ADDENDUM NO. 2 COVER SHEET

November 11, 2024

TERRE HAUTE AIRPORT AUTHORITY
WEST QUAD 6 UNIT BOX HANGAR PHASE 2
at
TERRE HAUTE REGIONAL AIRPORT (HUF)
TERRE HAUTE, IN
AIP 3-18-0082-057-2024

ADDENDUM NO. 2

SHEET NO:
CU202

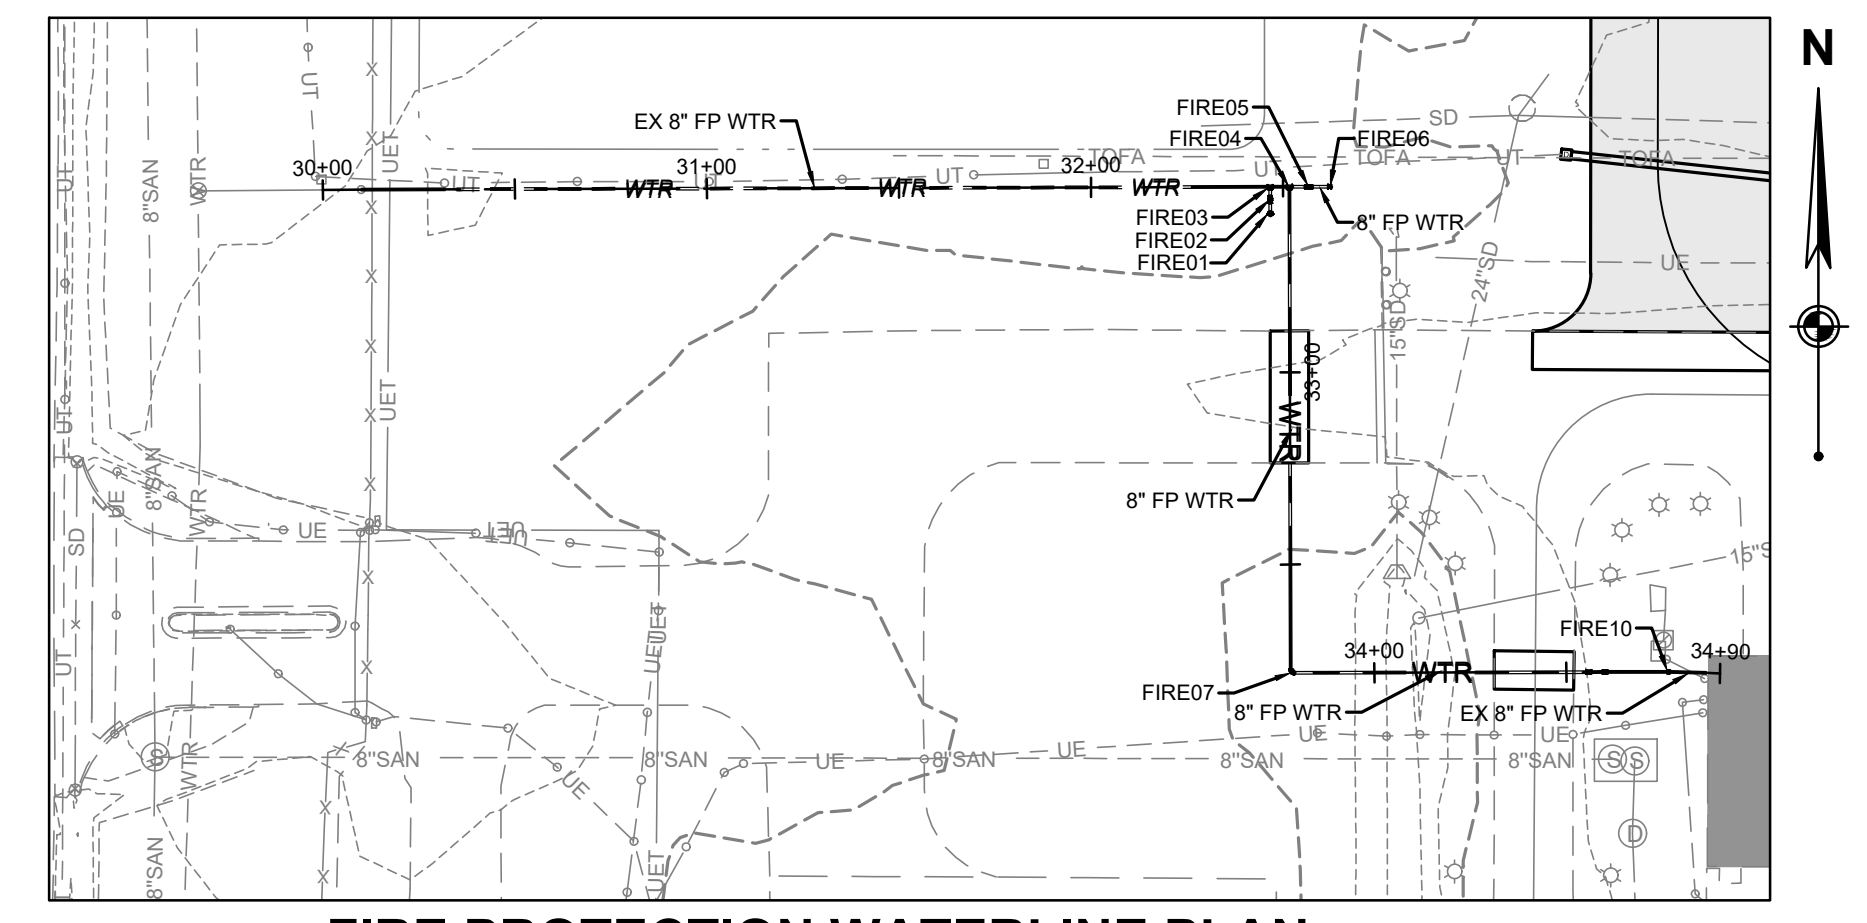
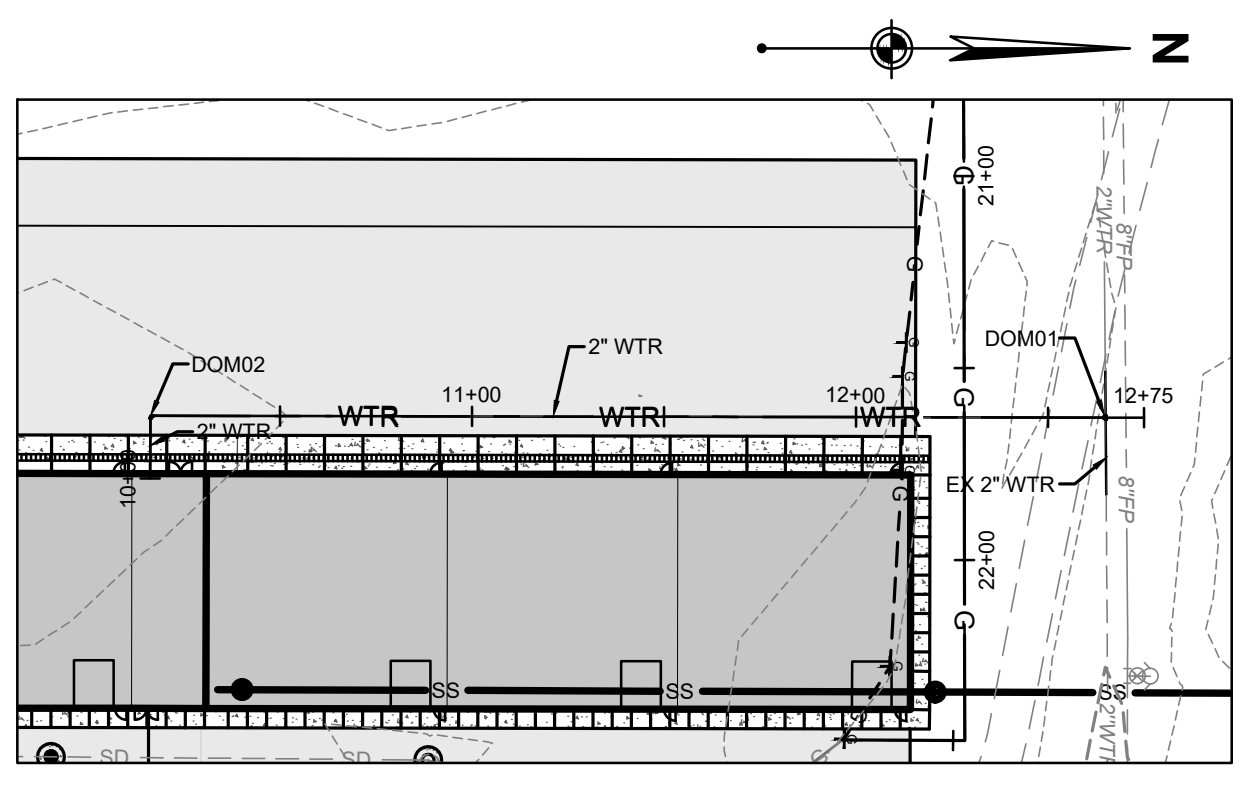
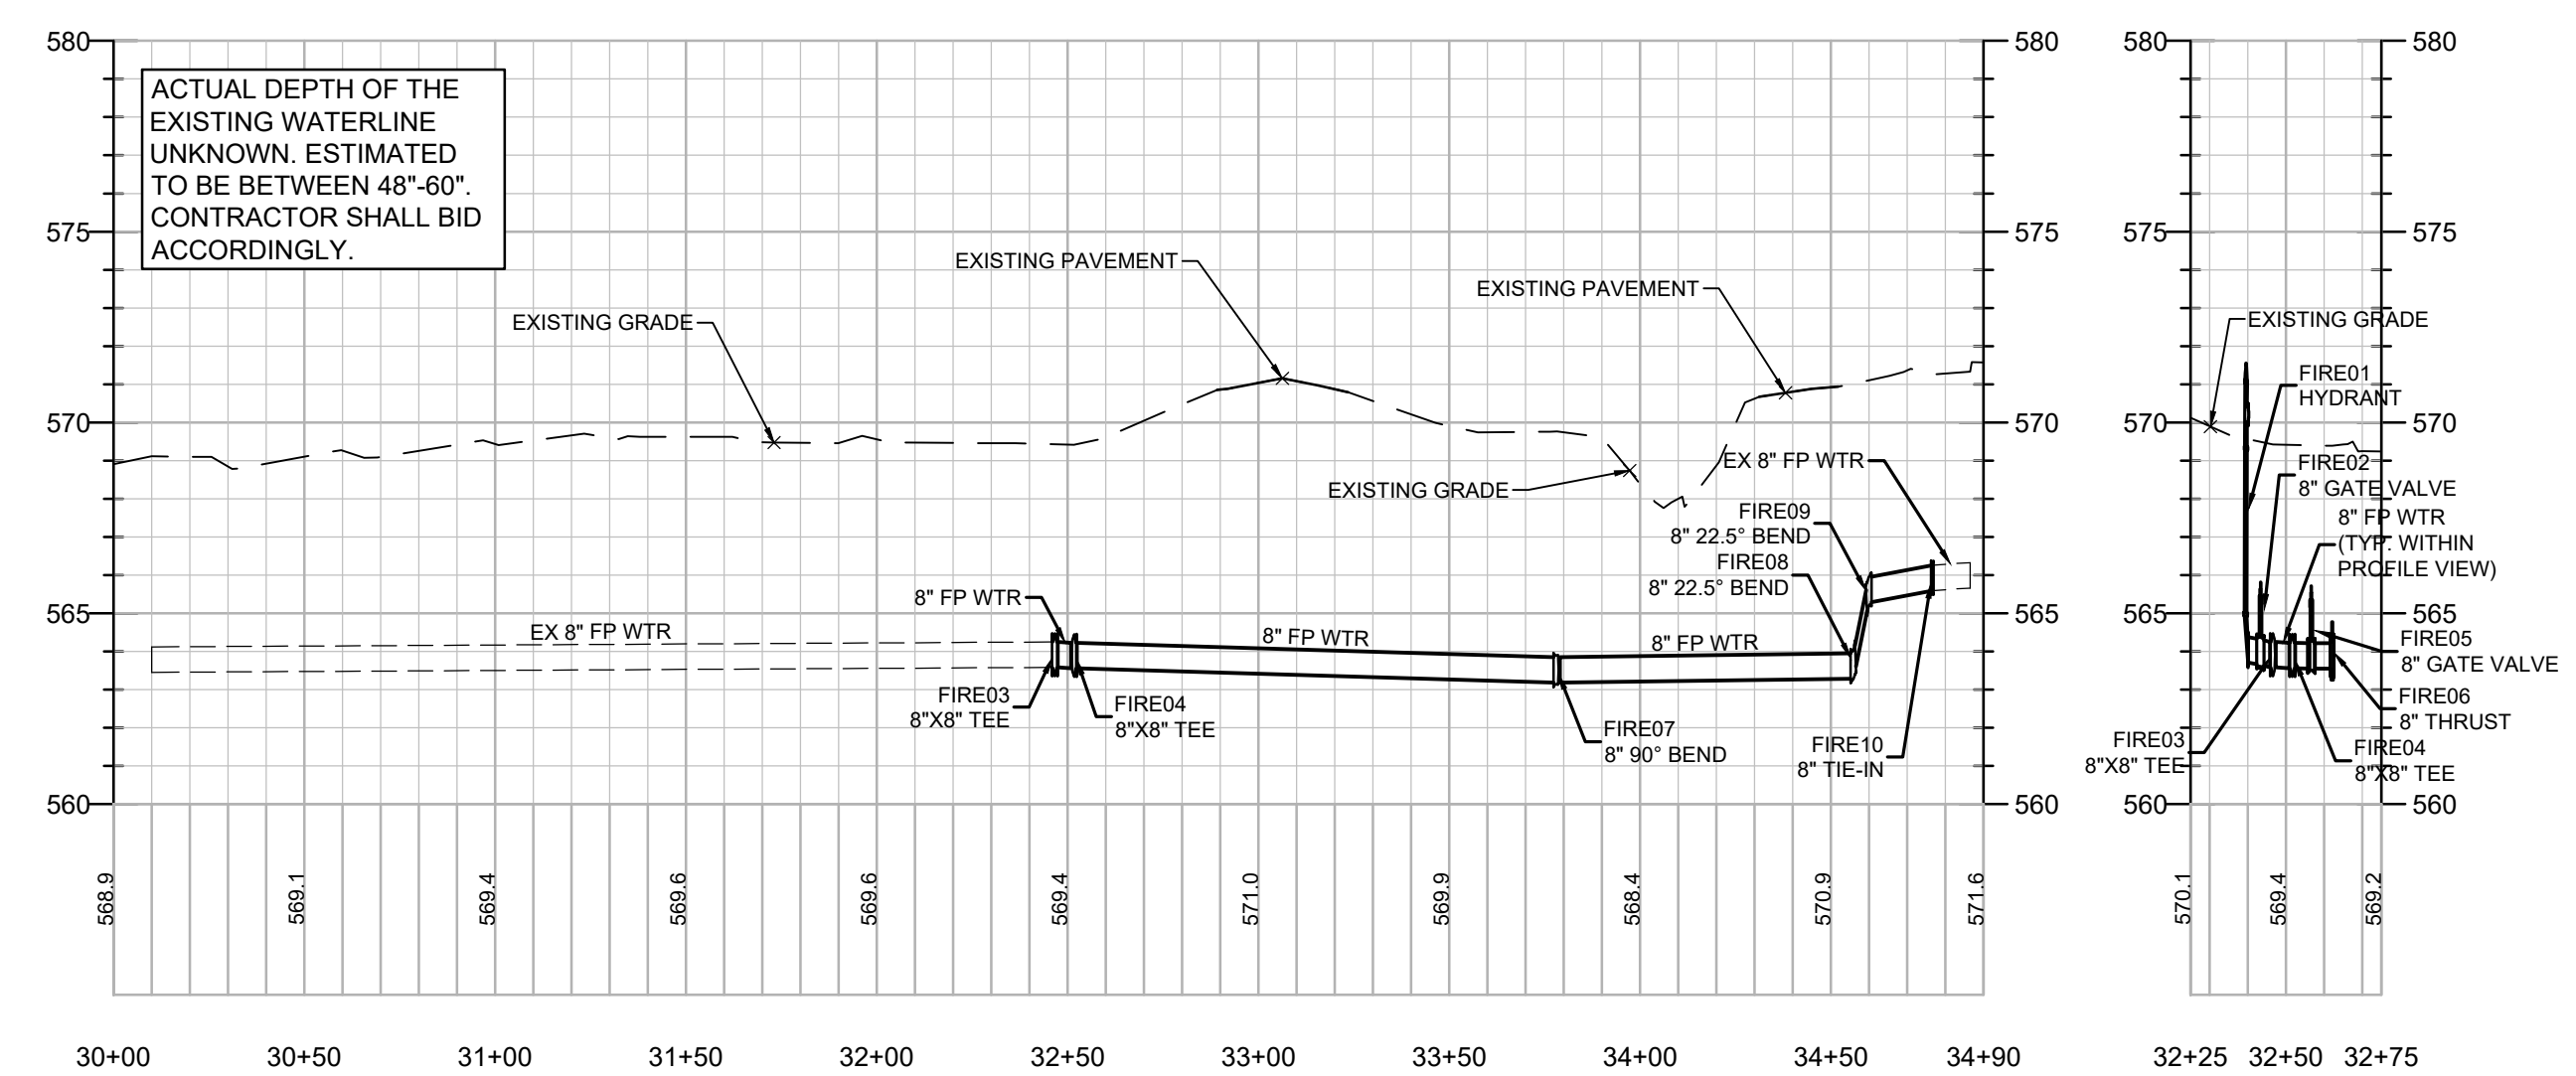
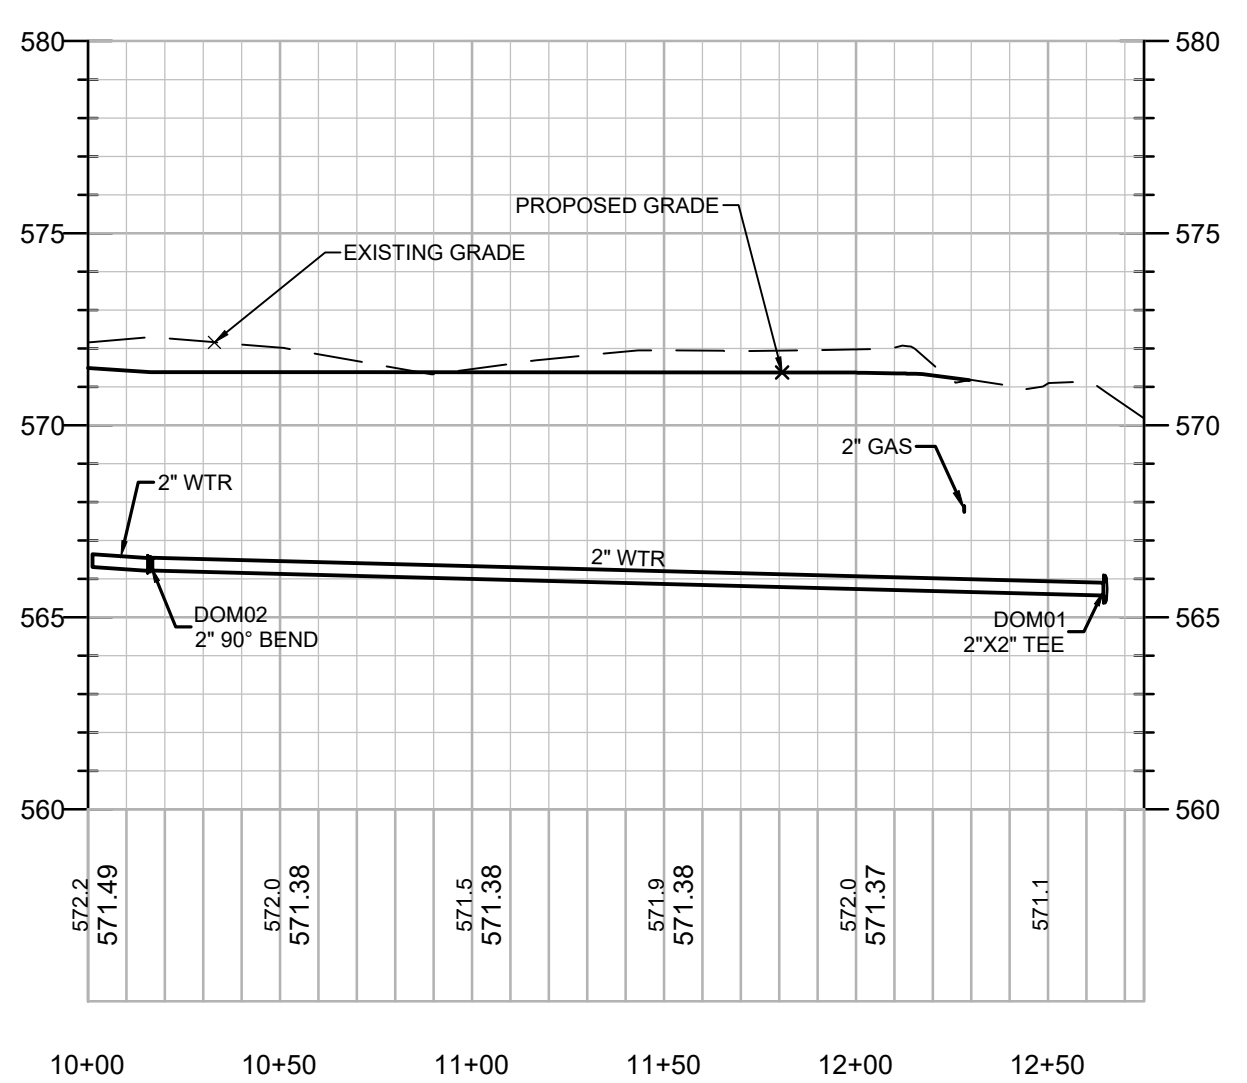
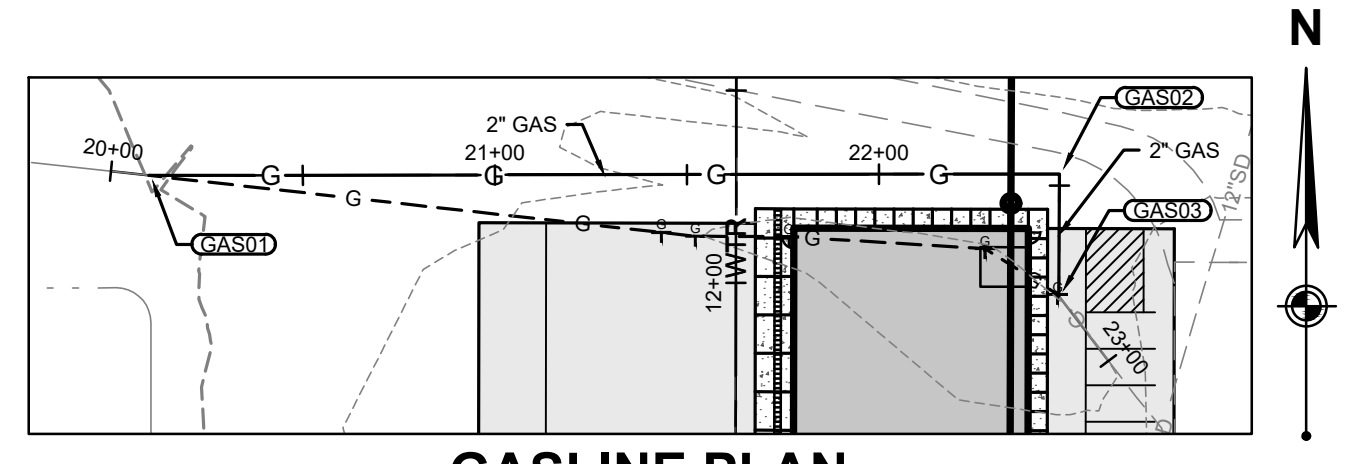
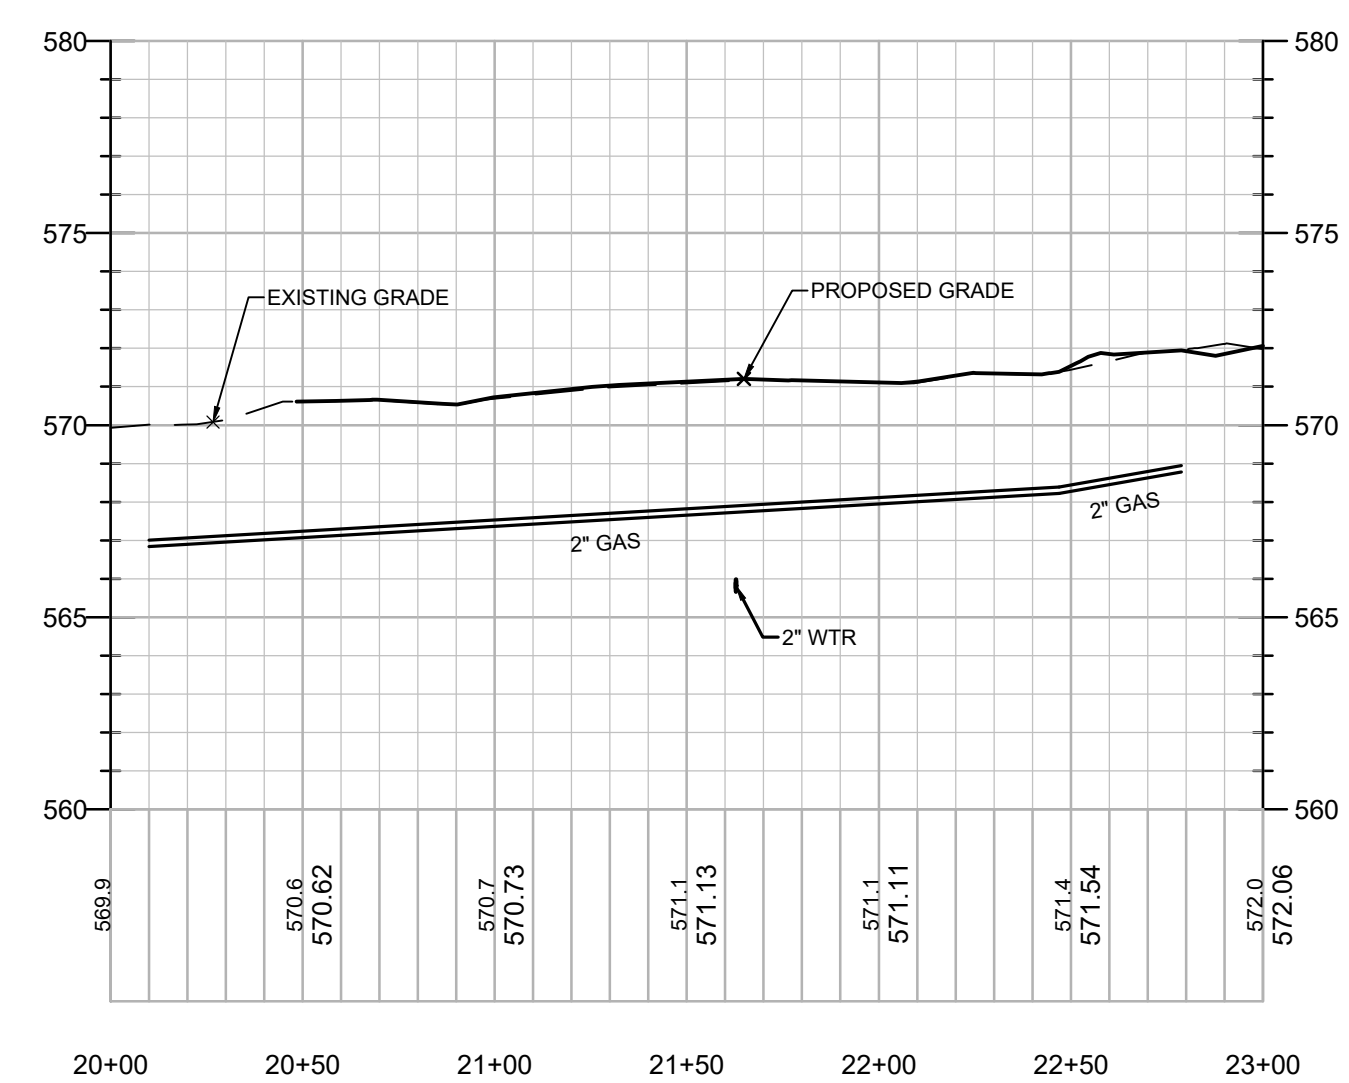
7. **Add:** "CU202 Waterline and Gas Plan and Profile" dated November 11, 2024, issued with this Addendum.
